Quick-check of the proposed logic to not activate the deployable system outside of the sensing width

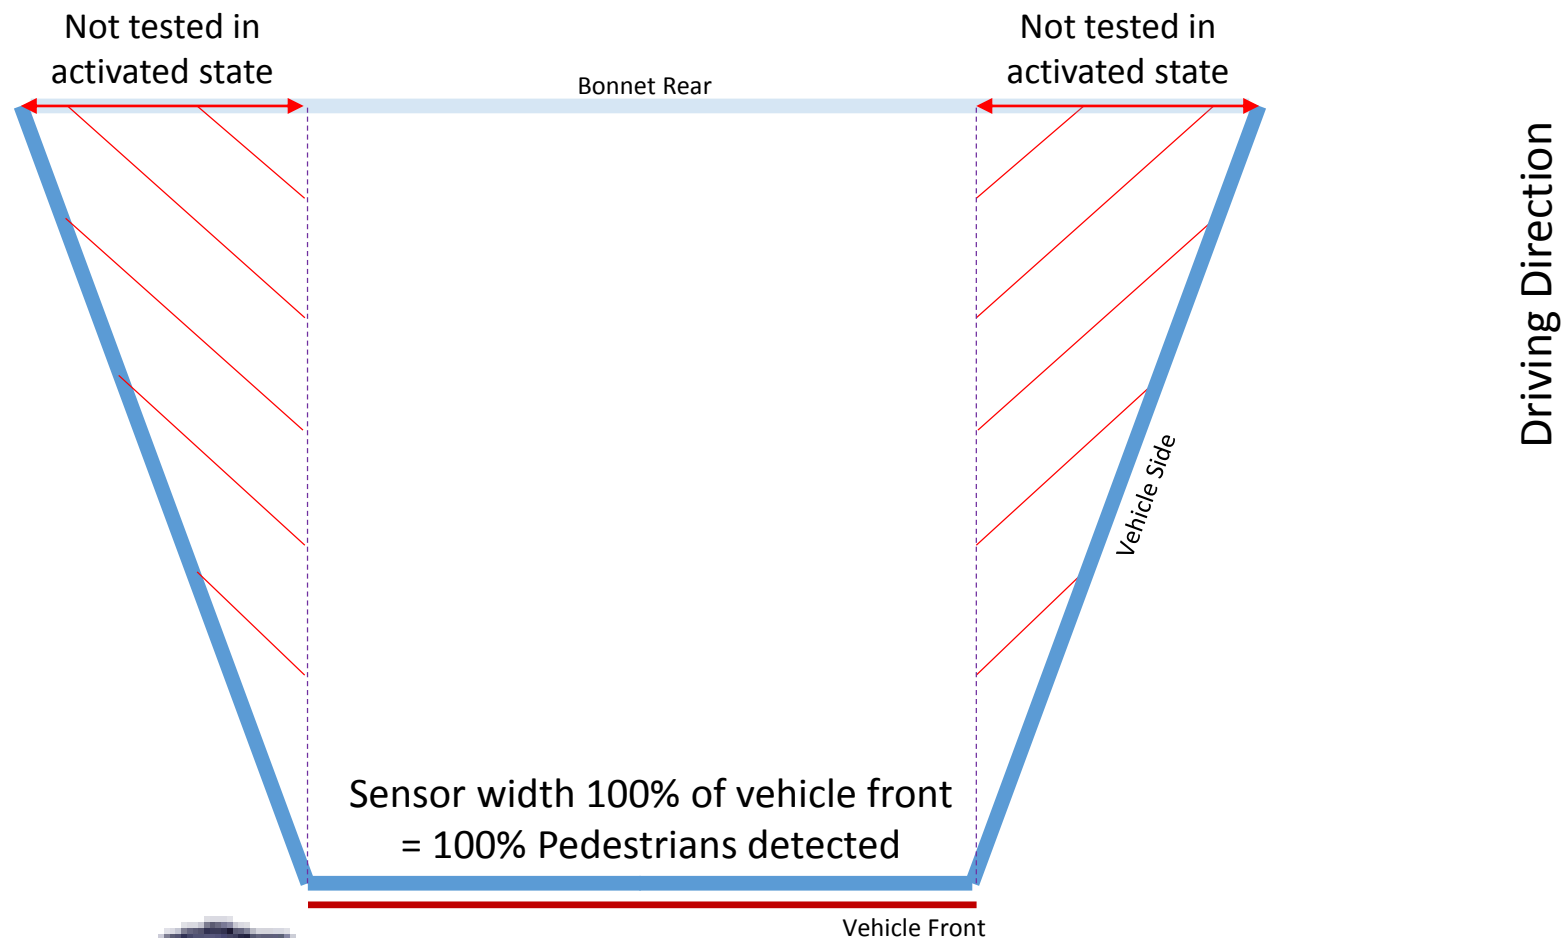
The leg excites the sensor but the condition for the head impact area would be closed, this can't be.
